August 28, 2001

**Re: GE-Pittsfield/Housatonic River Site  
30s Complex (GEC120)  
Supplemental Information for the June 2001 *Demolition/Consolidation Work Plan for  
Buildings 31, 31-J, and 31-P***

**BUILDING 31 BASEMENT TCLP  
SAMPLING LOCATIONS**

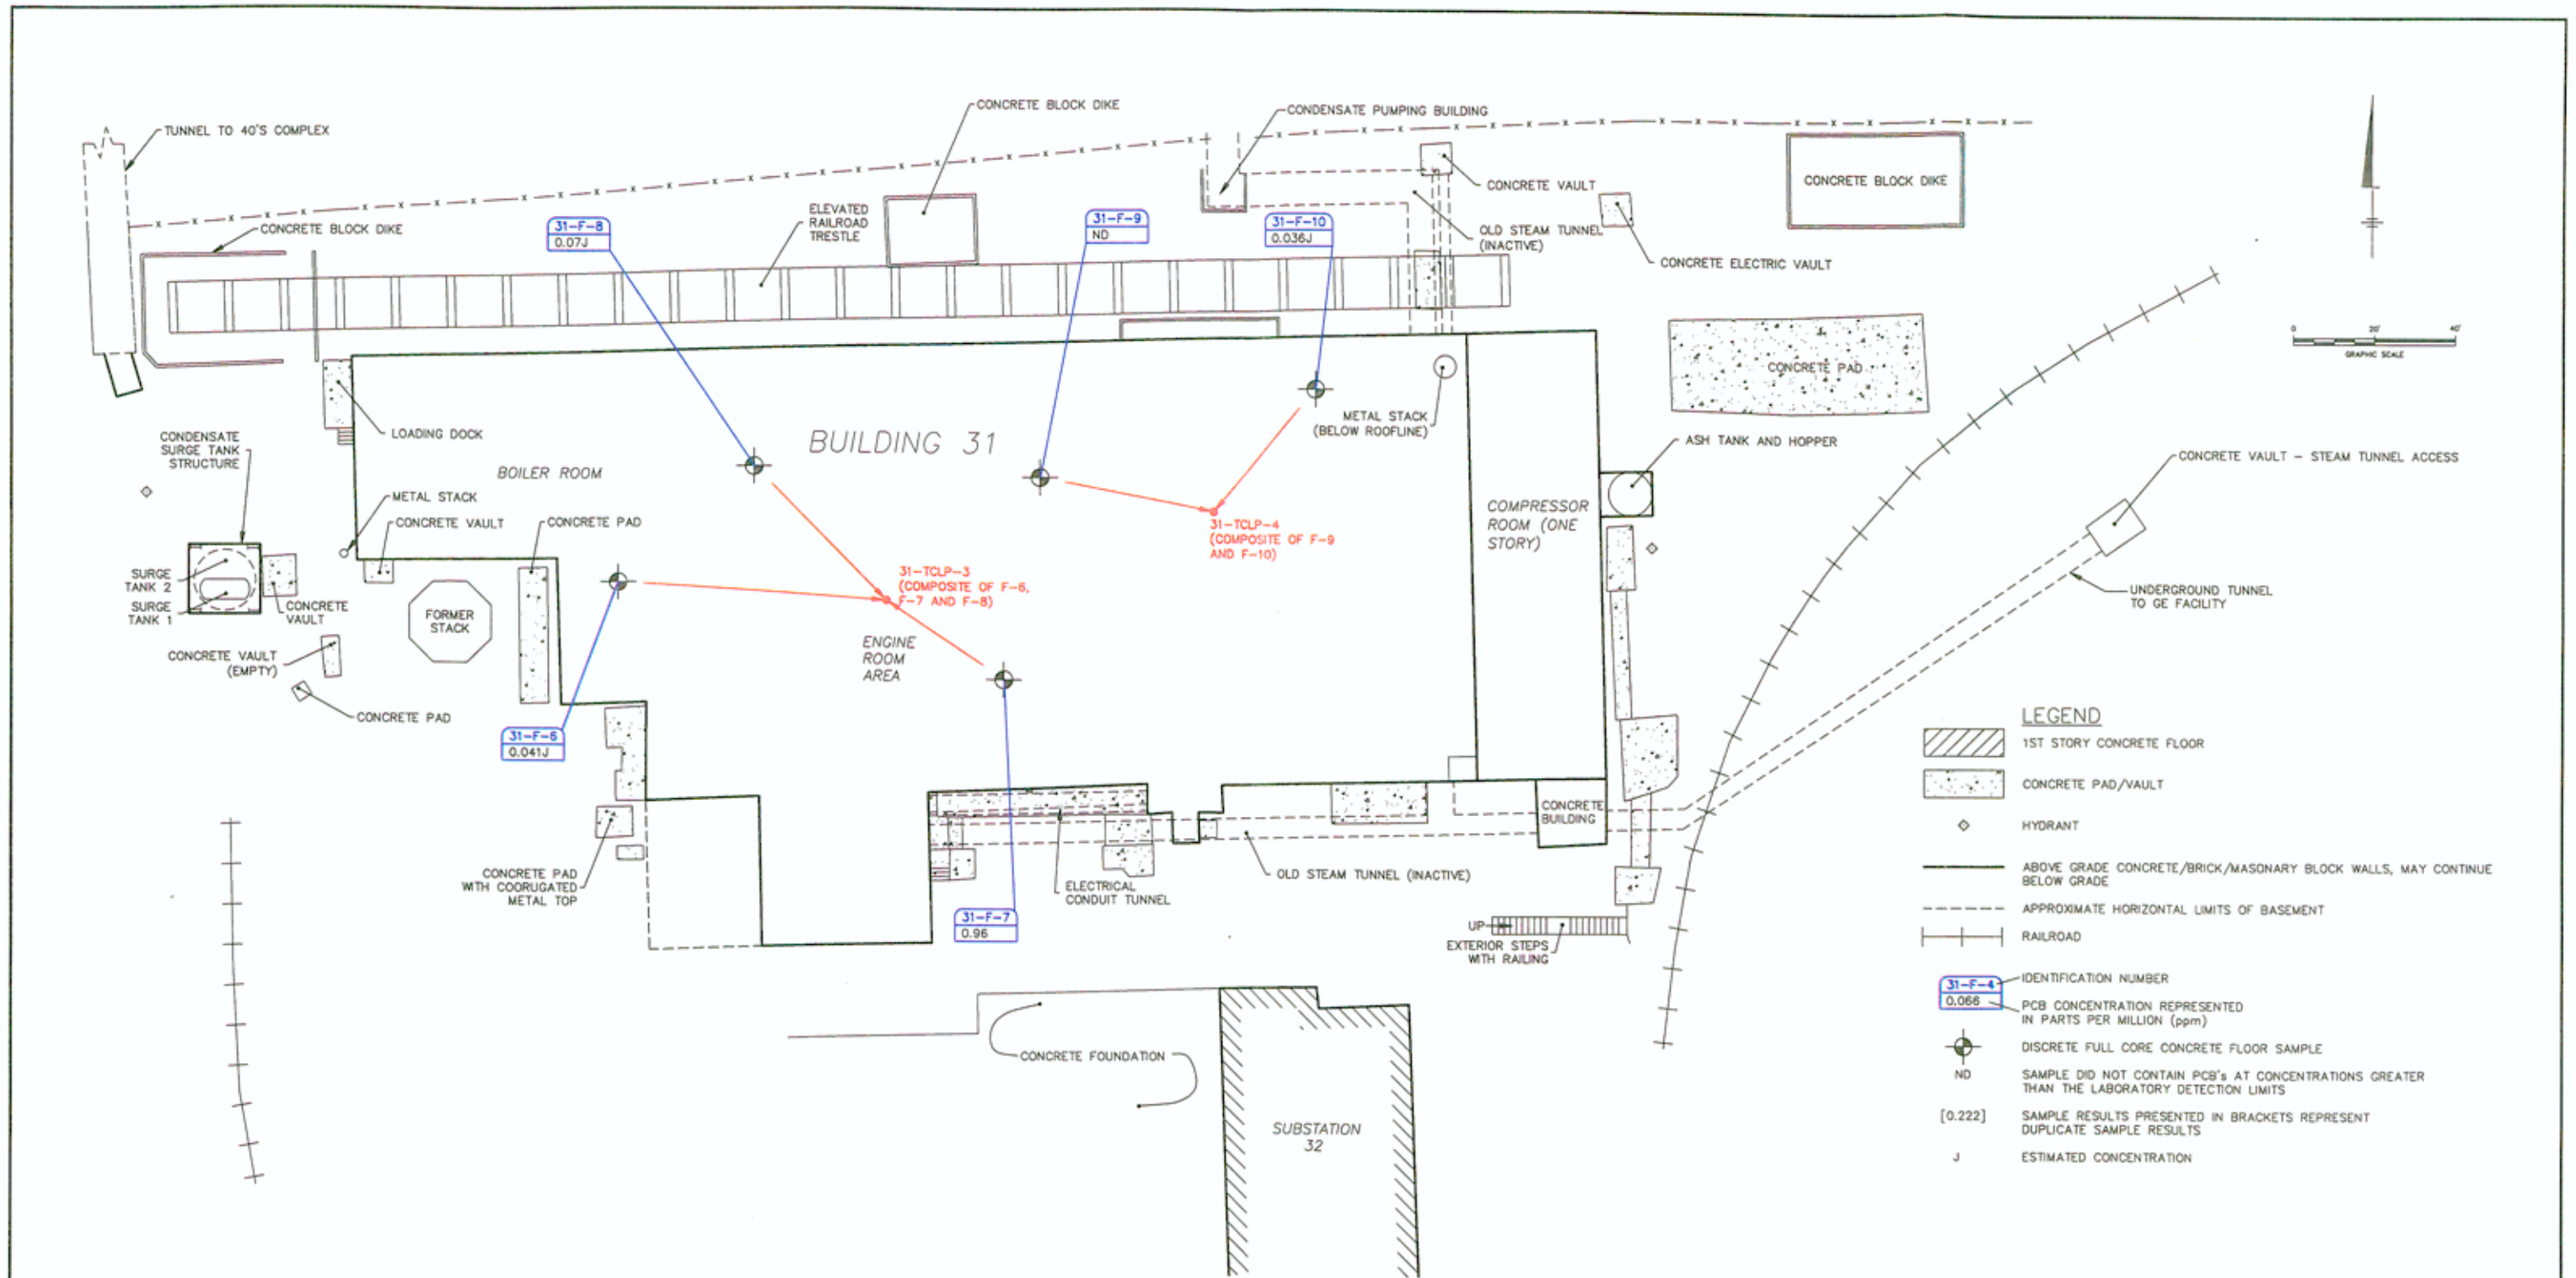
During the August 15<sup>th</sup> meeting, EPA requested that GE identify the locations of the Toxicity Characteristic Leaching Procedure (TCLP) samples that were collected in Building 31. Attachment D, Section 1 of the Work Plan provides a summary of the Building 31 characterization data collected by GE, including the results of TCLP sampling activities. Figures depicting the locations of those TCLP

sampling activities were inadvertently omitted from the Work Plan, but are included as Attachment A to this letter.

As indicated on the figures presented in Attachment A, the samples collected for TCLP analysis were composites of sampling media (concrete) obtained from the same locations on the basement and first floors of Building 31 where PCB sampling was conducted. Specifically, five TCLP samples were collected and composited from 14 locations. All sample results were non-detect for volatile organic compounds, semi-volatile organic compounds, and inorganic constituents. Also, other testing for hazardous waste characteristics (ignitability, reactive cyanide, reactive sulfide, and corrosivity) indicated that the material would not be classified as RCRA hazardous waste.

**BUILDING 31 BASEMENT TUNNELS**

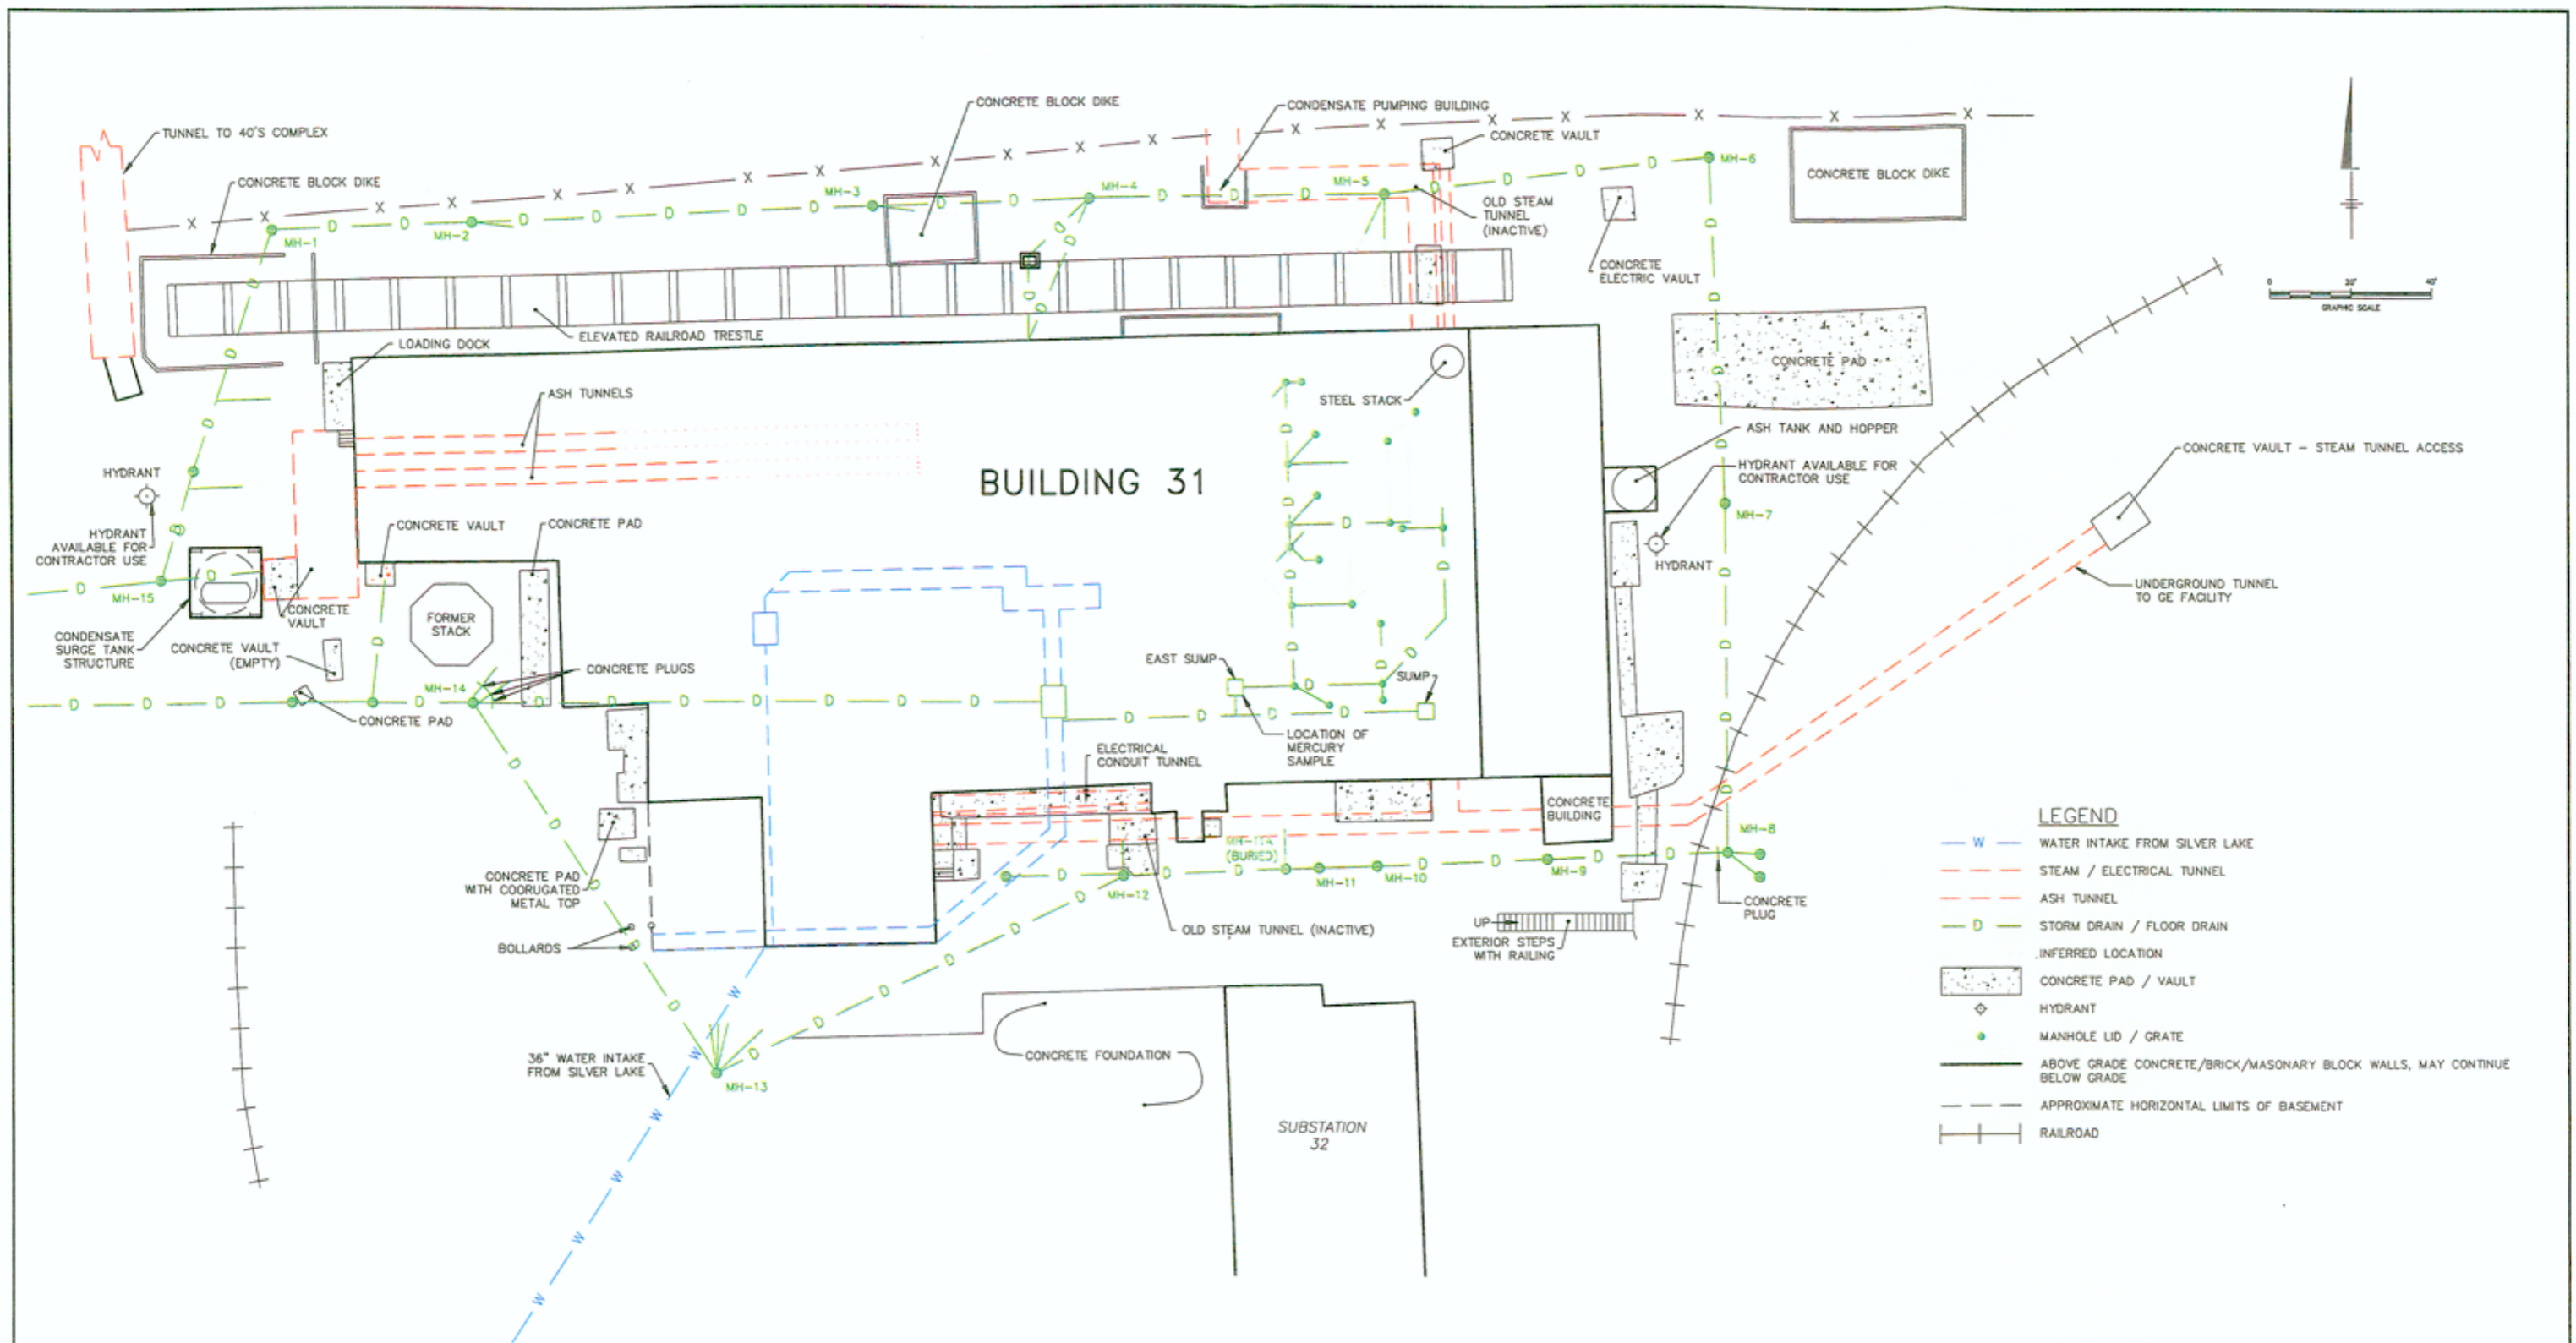
In communications with GE prior to the August 15<sup>th</sup> meeting, EPA requested certain information about the presence of mercury in Building 31. Specifically, EPA identified the collection of a sediment sample within an interior Building 31 sump, which had been collected on May 22, 1991, and found to contain 3,890 parts per million (ppm) total mercury, and it inquired as to the location of that sump. In addition, EPA inquired as to the presence of mercury previously noted on the Building 31 floor and exterior of the mercury reservoirs in metering closet #5. During the August 15<sup>th</sup> meeting and site visit, GE provided additional information related to the locations of the sump and metering closet #5 within Building 31. Attachment B to this letter provides an updated Figure 3 from Attachment D of the Work Plan showing the sump location.

GE has subsequently measured the thickness of the sediment in the sump. The measurements indicated a sediment thickness of approximately 1.1 feet within the approximately 6.5 feet by 2.5 feet by 4.7 feet deep sump. In light of our recent discussions, GE will remove the mechanical equipment (e.g., pumps, pipe, valves, etc.), water, and sediment from the sump, dispose of these materials off-site, and backfill the sump with concrete or grout prior to the building demolition and consolidation activities.

# **Photographs of Ash Tunnels**

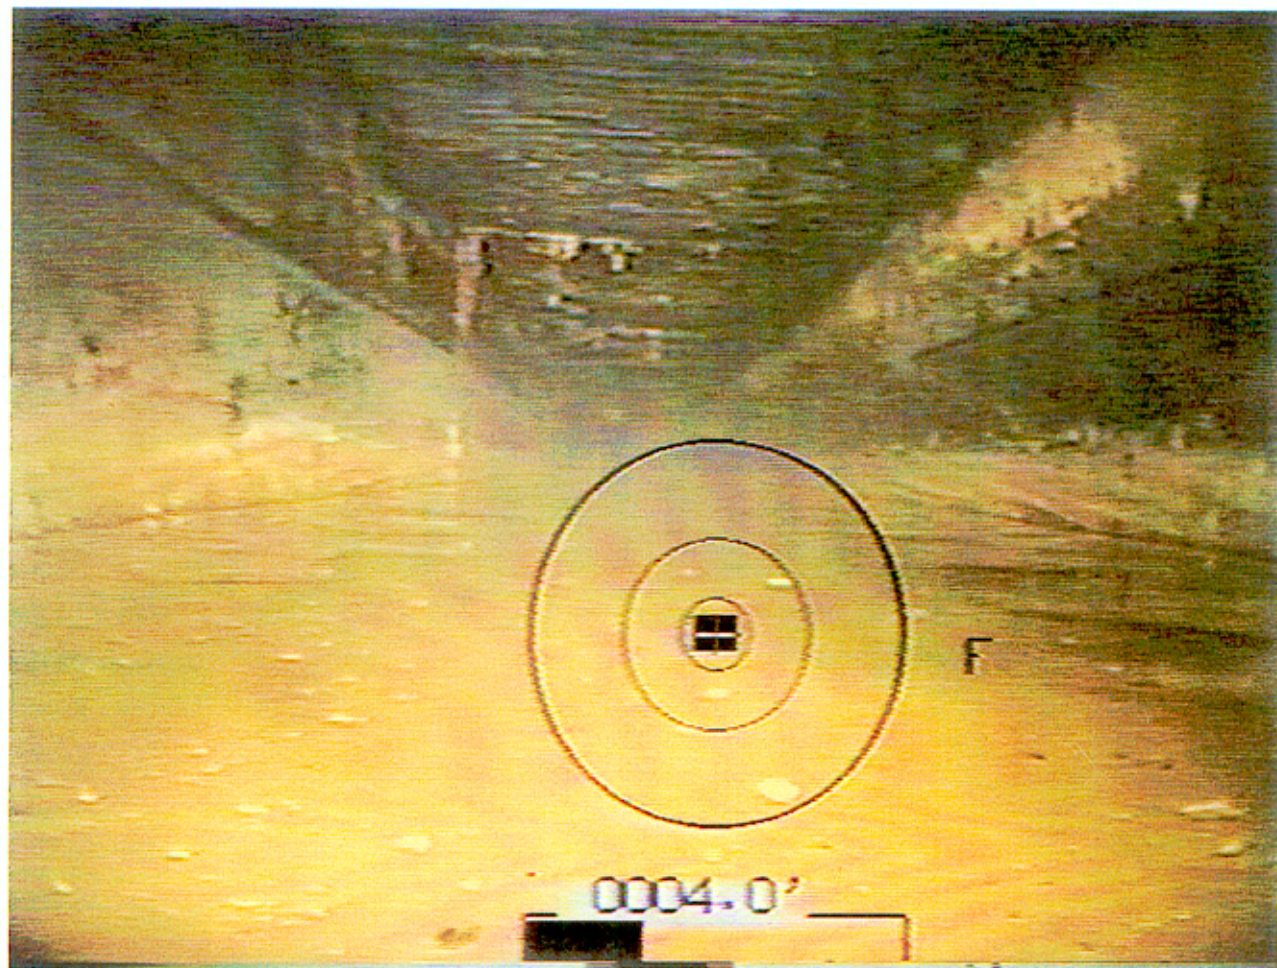
During the August 15<sup>th</sup> meeting and site visit, EPA made inquiries regarding the amount of coal ash remaining in the ash tunnels beneath the Building 31 basement floor. EPA also requested results of any analytical testing performed on the coal ash. In response, GE indicated that the ash tunnels were partially drained and videotaped in 1999, and that the ash in the tunnels appears to have been removed. Certain representative portions of that videotape have been reproduced (in the form of still photos) and are included in Attachment C to this letter. As can be seen from the photos, there does not appear to be any residual ash remaining in the tunnels. Notwithstanding this visual confirmation, and as indicated in the Work Plan, GE will backfill the tunnels in their entirety with concrete or grout prior to demolition and consolidation activities.

Results of analytical testing performed for the coal ash are also included in Attachment C. The coal ash sample was collected in 1991 from the bottom of the former Building 31 smoke stack. The results of the testing indicate that the material exhibits the characteristic of toxicity for chromium. However, since the coal ash is derived from fossil fuel, it is considered a non-hazardous waste under 40 CFR 261.4(b)(4) and 310 CMR 30.104(9).
